# 1963 Corvette: Service Bulletin: Transmission Shift Lever Vibration

**Subject:** Transmission Shift Lever Vibration  
**Model and Year:** 1963 1000 Series, Chevy II and Corvette with Floor Mounted Shift Lever  
**Source:** Chevrolet Technical Service Bulletin  
**Bulletin No:** DR #595  
**Section:** VII  
**Date:** June 24, 1963

FIG. 1

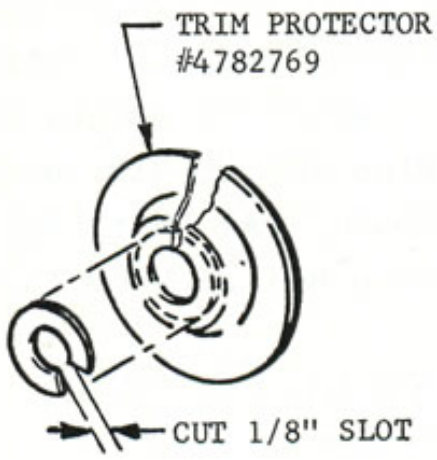
A plastic insulating washer, approximately 1" O.D., fabricated from trim protector No. 4782769 (see fig. 1, below) will be required on all vehicles produced prior to November 15, 1962, when a complaint of shift lever "buzzing" is encountered.

Effective in production approximately November 15, 1962, the shift lever was revised to incorporate a Delrin insulating washer between the shift lever and the bracket. A similar washer may be fabricated from trim protector No. 4782769 and installed as outlined in this bulletin to correct early vehicles.

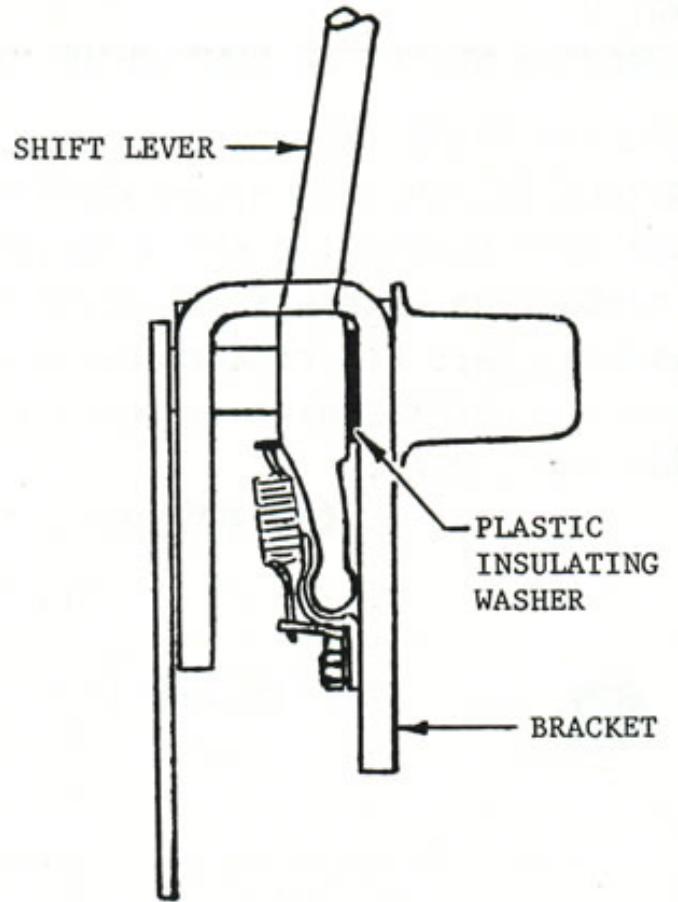
With the shift lever assembly removed from the vehicle, insert the above fabricated insulator washer on the shaft between the lever and bracket. (See Figure 2, below)

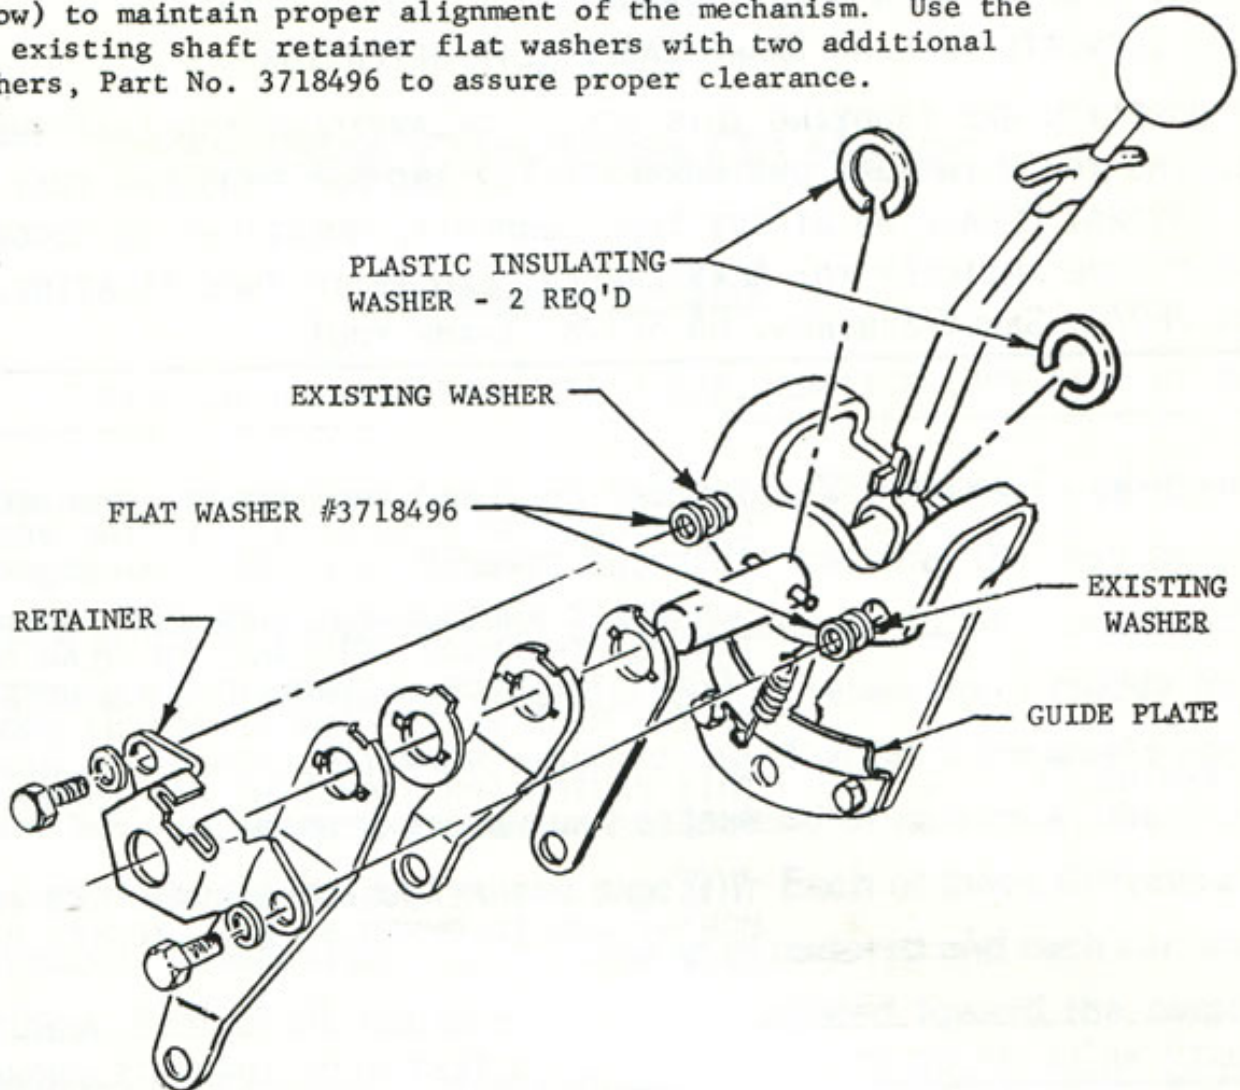
With the shift lever assembly removed from the vehicle, insert one insulator washer between the lever and bracket and another insulator washer between the bracket and pin, (See Figure 3, below) to maintain proper alignment of the mechanism. Use the two existing shaft retainer flat washers with two additional washers, Part No. 3718496 to assure proper clearance.
